REMOVED BOTTOM NOTES IN TITLE BLOCK		Supplier's/Purchaser's No.	
		LIGO-BEAM TUBE HANFORD, WA & LIVINGSTON, LA CIRCUMFERENTIAL LEAK TEST BOX GENERAL VIEW	
		Customer's No.	Contract No.
		By CLD Chkd DWD Date 2-26-96	953571
		M. L. TELLALIAN Engineering Supervisor	Dwg. ER600 Rev. 1 Sheet
		LIGO-D970053-01-B

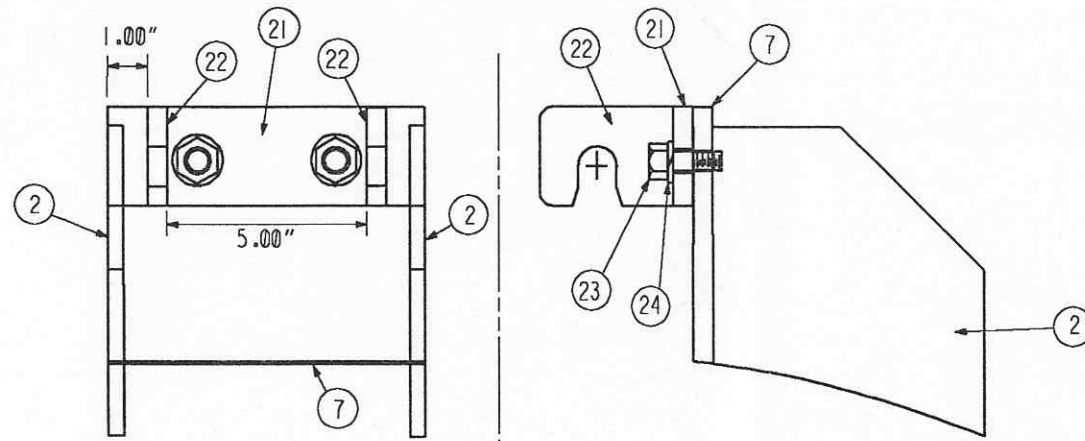
INDICATES CHANGE FROM PREVIOUS ISSUE
